**ENVIRONMENTAL LICENSING PROGRAMME MEMORANDUM**

<b>TO:</b>	DARA LYNOTT, DIRECTOR
<b>C.C:</b>	Frank Clinton, Programme Manager
<b>FROM:</b>	Brian Meaney, Senior Inspector
<b>DATE:</b>	20 <sup>th</sup> January 2012
<b>RE:</b>	Request for a Technical Amendment to Waste Licence Register Number <b>W0220-01</b> , held by <b>Greenstar Ltd</b> in relation to a transfer station at <b>Ramstown, Gorey, Co. Wexford</b> .

GREENSTAR LTD  
 PROPOSED  
 LICENSE AREA  
 04/22-01  
 04/22-01

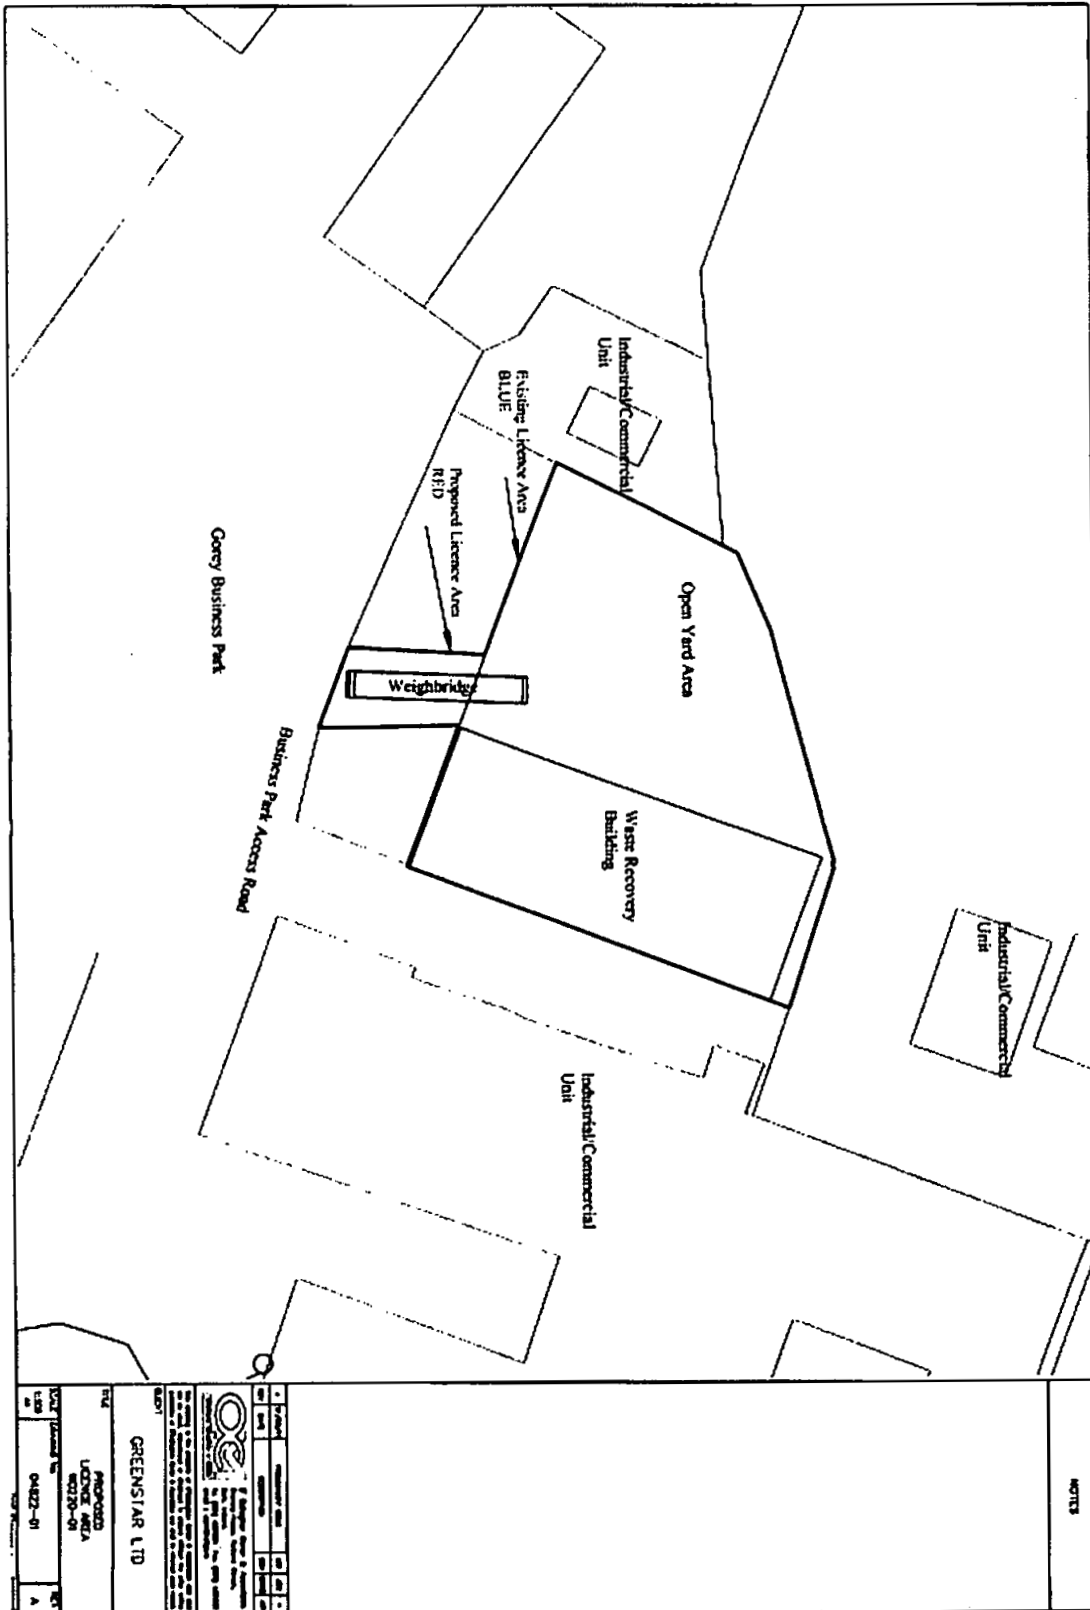
The licensee has requested amendment under Section 42B of the Waste Management Acts 1996 to 2008. The technical amendment relates to condition 1.5 of the licence that refers to a drawing defining the boundary of the licensed area. An extension to the licensed area is requested in order to provide for the installation of a weighbridge at the facility.

The attached drawing illustrates the licensee's proposal. The new weighbridge cannot be accommodated within the existing site boundary due to the size of the weighbridge, the layout of the site entrance and for health and safety and manoeuvrability reasons. The facility is located in an industrial estate. The landowner, Gorey Business Park, has no objection to the relocation of the weighbridge at the entrance to the facility.

For the reasons outlined above I recommend that the Agency agrees to a technical amendment of licence register number W0220-01 under Section 42B(1)(c) of the Waste Management Acts 1996 to 2011.
